febi EXAKT

Tie rod end

fits AUDI A4, A6, A8 (ref. no. 4BO 419 811 E)
VW Passat (ref. no. 4BO 419 811 E)
Skoda Superb (ref. no. 4BO 419 811 E)

febi no. 22044

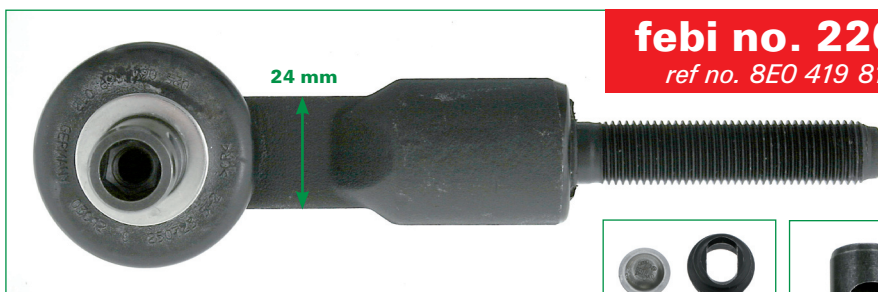
The ball joints on the tie rod ends cause noise whilst driving

Premature failure due to overloaded joints of the old design (ref. no. 4BO 419 811 E). This version has been replaced and is no longer fitted by Audi, VW and Skoda.

- Larger diameter to increase the load carrying capacity
- Sturdier body
- Snap ring is replaced by a flange to protect the rubber boot.

With the new design, the rubber remains in the body to ensure a comfortable driving experience and to prevent high-frequency vibrations being transferred to other parts.

febi recommends the use of the tie rod end febi no. 22044 (ref. no. 8EO 419 811 B)
